CITY OF HARTFORD
DEPARTMENT OF ENGINEERING
SOUTH MEADOWS
PUMPING STATION
MOTOR ROOM FLOOR AND
INTERIOR CONDUIT DETAILS
MAY 29, 1931
SCALE: AS NOTED
MADE: W.B.M. N.S.P. APPROVED: DAYBOOK NO.
CHECKED: W.B.M. N.S.P. 06956

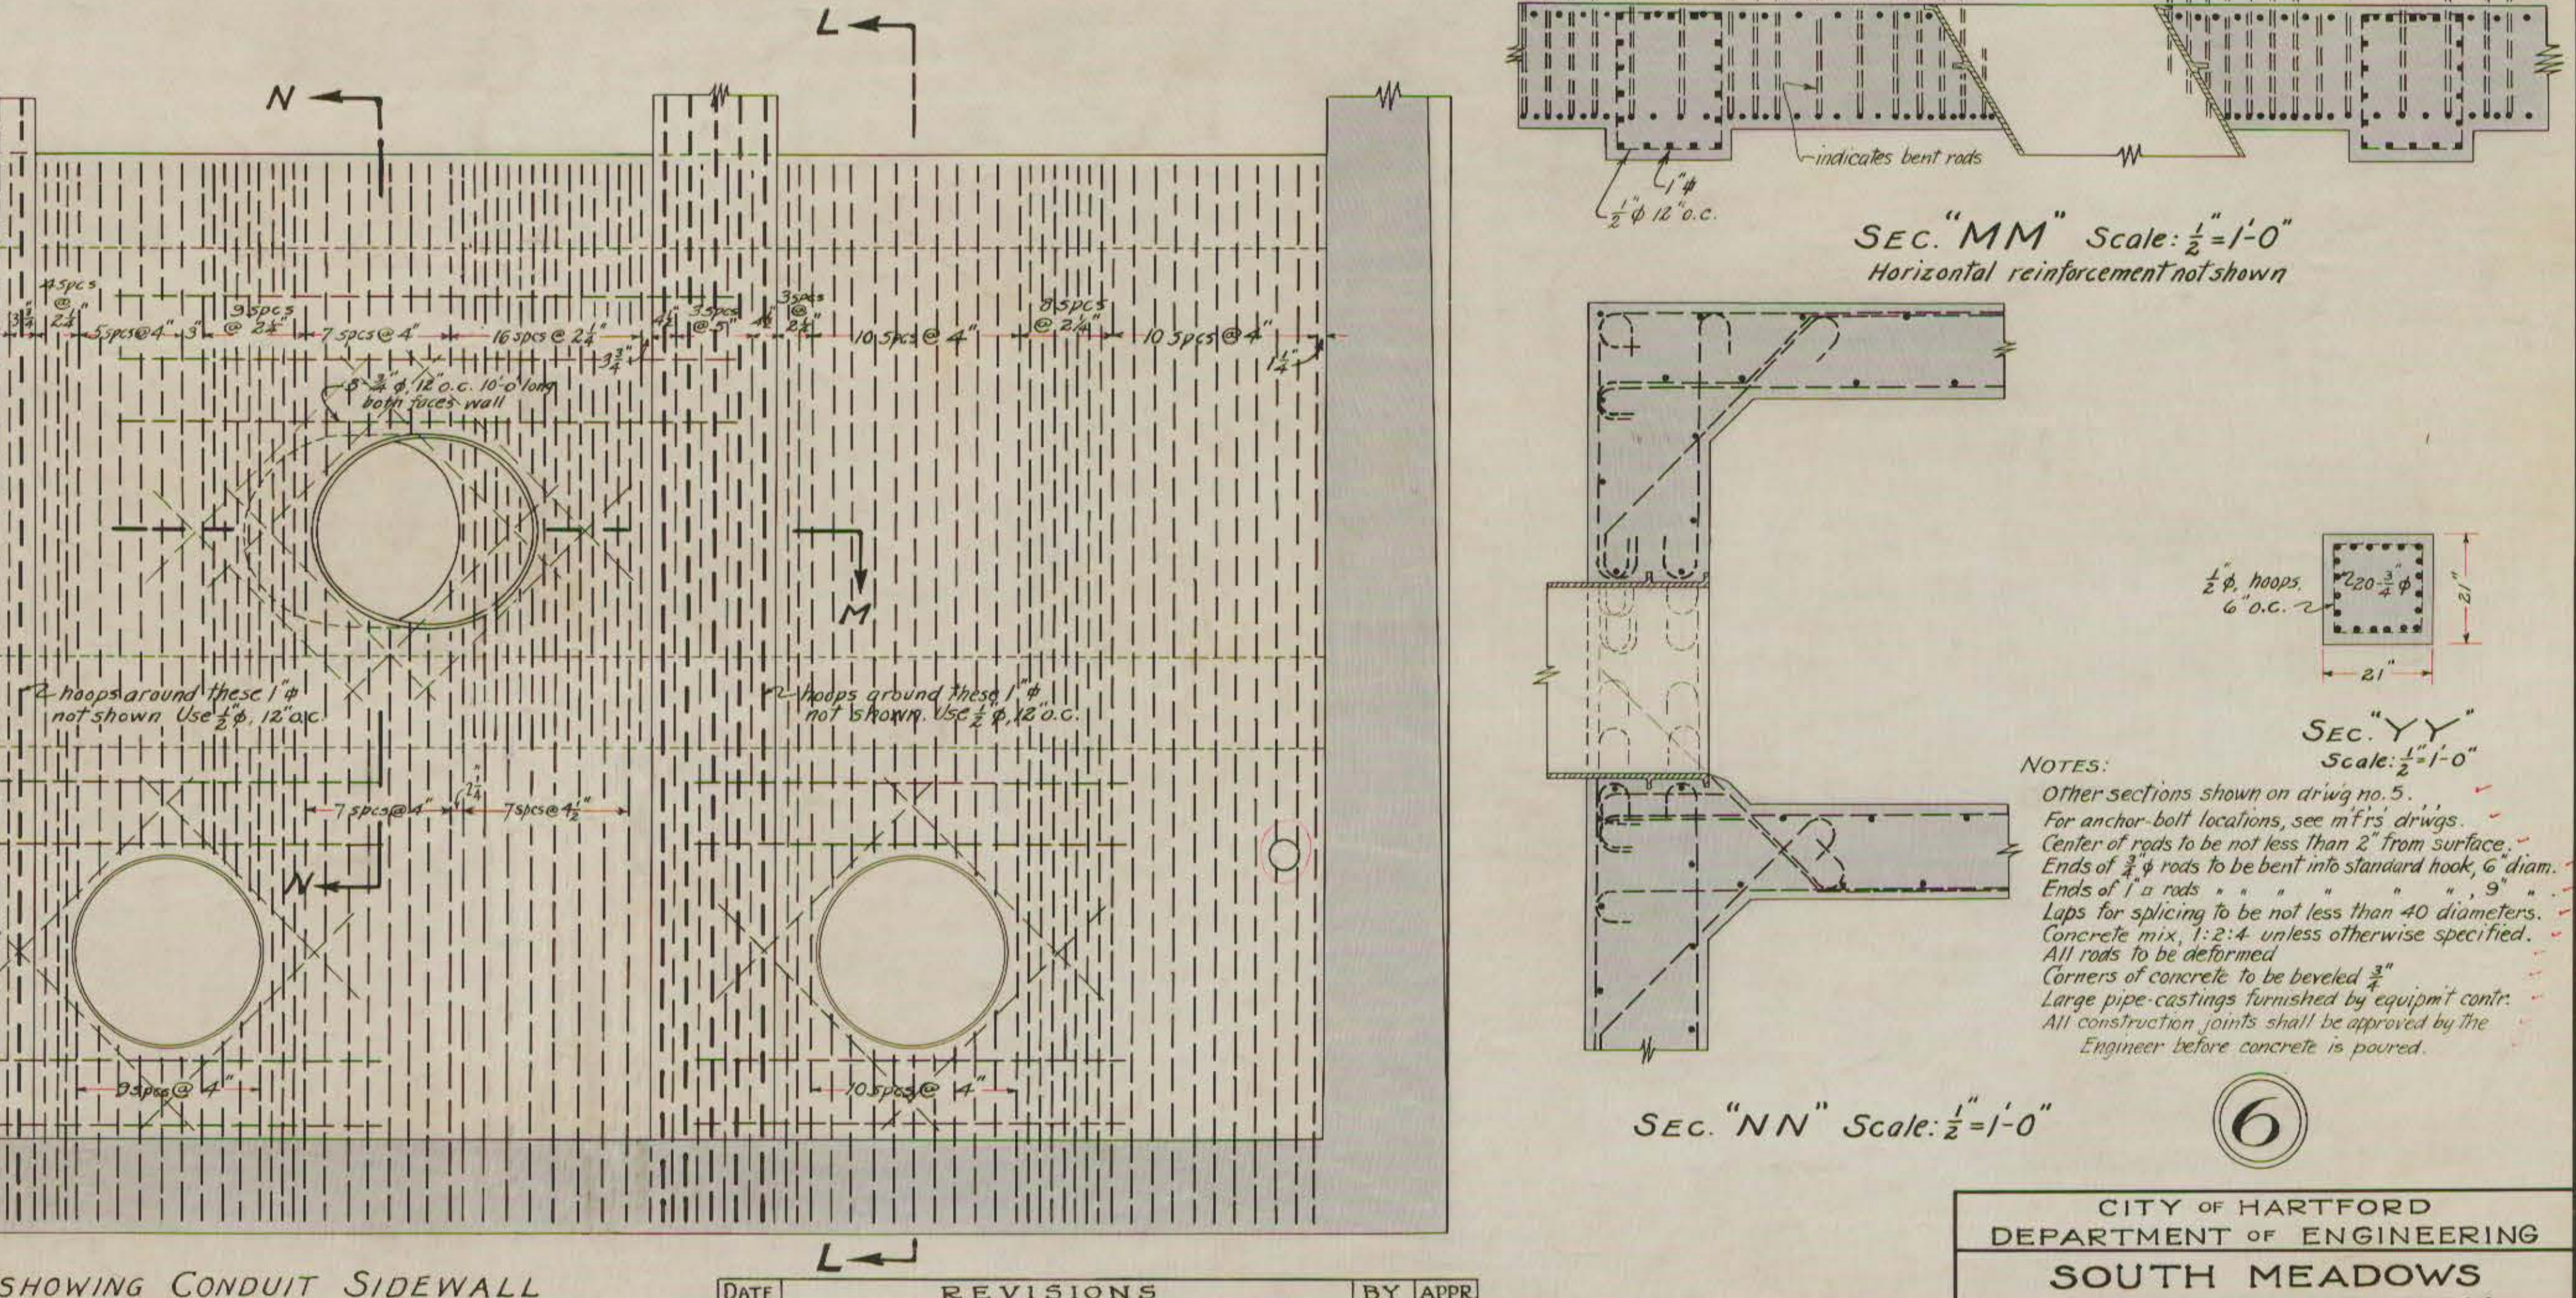
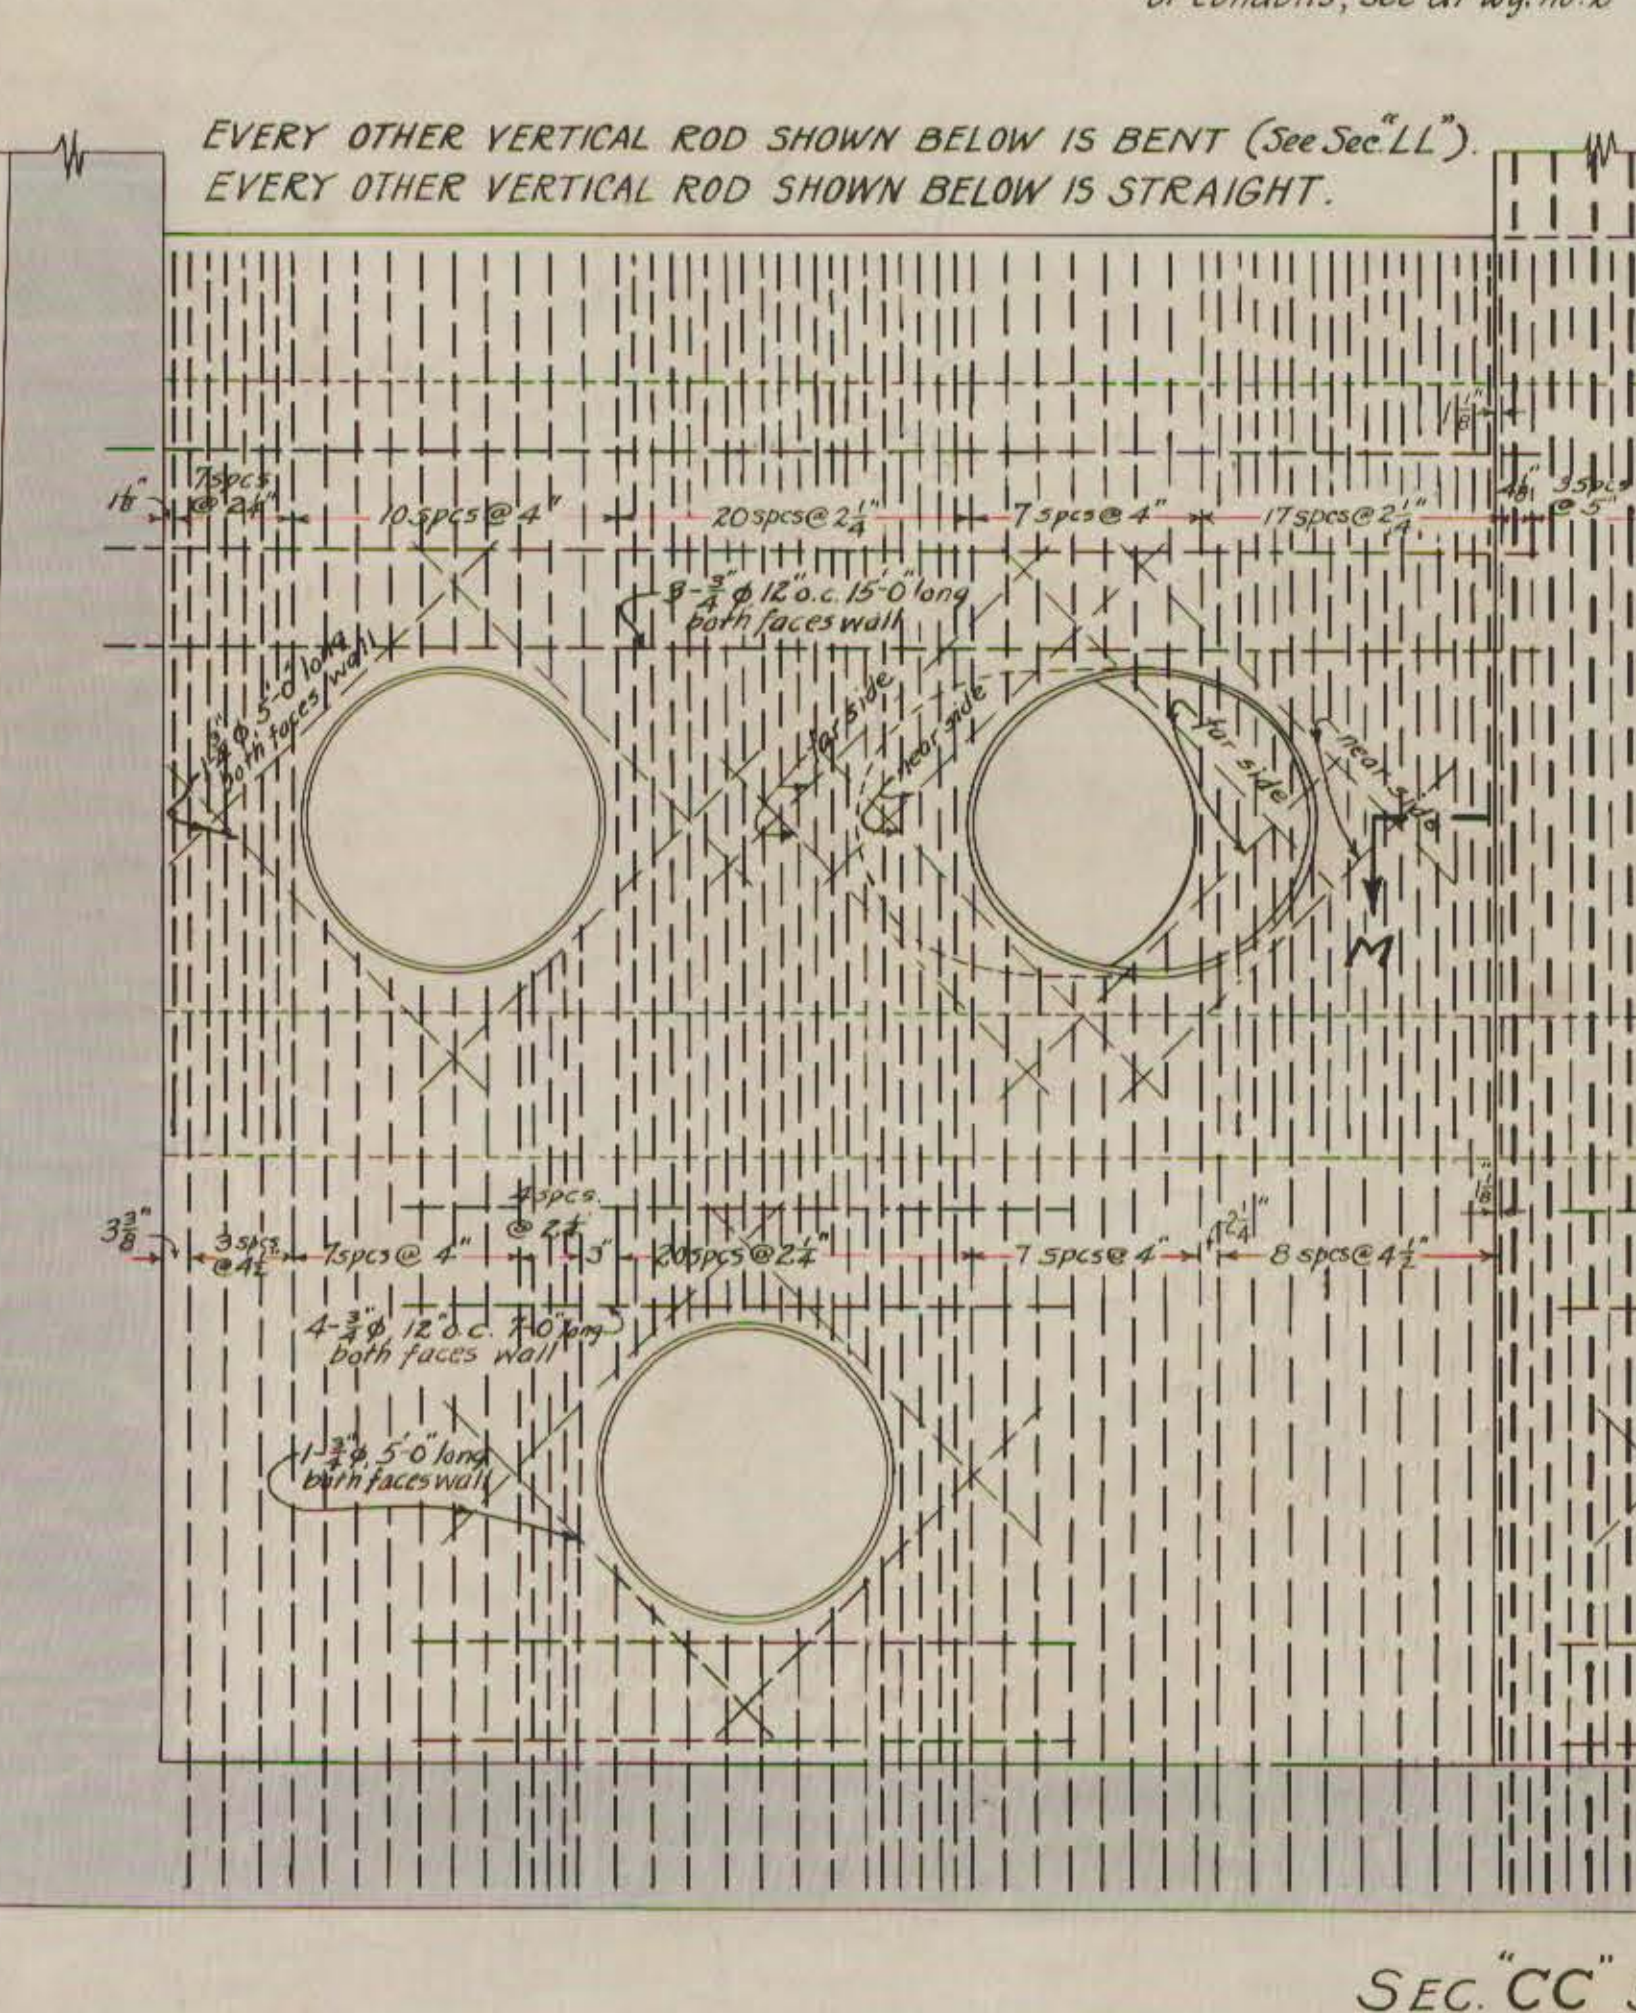
DATE	REVISIONS	BY	APPR
7-1-31	Plan of Motor Room Floor, added sleeves for float switches, S.W. cor.	N.S.P.	N.S.P.
7-2-31	Gate Stand Supports, added rebar, see CC, scale 1/4"=1'-0" section.	N.S.P.	N.S.P.
7-3-31	Details of Covers, corrected position of 2 1/2" P.I.	N.S.P.	N.S.P.
7-4-31	Plan of Motor Room Floor, changed radius ball circle pump motor base	N.S.P.	N.S.P.
7-5-31	SEC. CC' added section that switch pipe	N.S.P.	N.S.P.
7-6-31	Plan of Motor Room Floor, added radii for pipe sleeves, set and pipe sleeves	N.S.P.	N.S.P.
7-7-31	Plan of Motor Room Floor, added dimensions to exciter anchor bolt pipe sleeve	N.S.P.	N.S.P.
8-19-31	Plan of Motor Room Floor, changed radius ball circle pump motor base & 7 1/2"	N.S.P.	N.S.P.
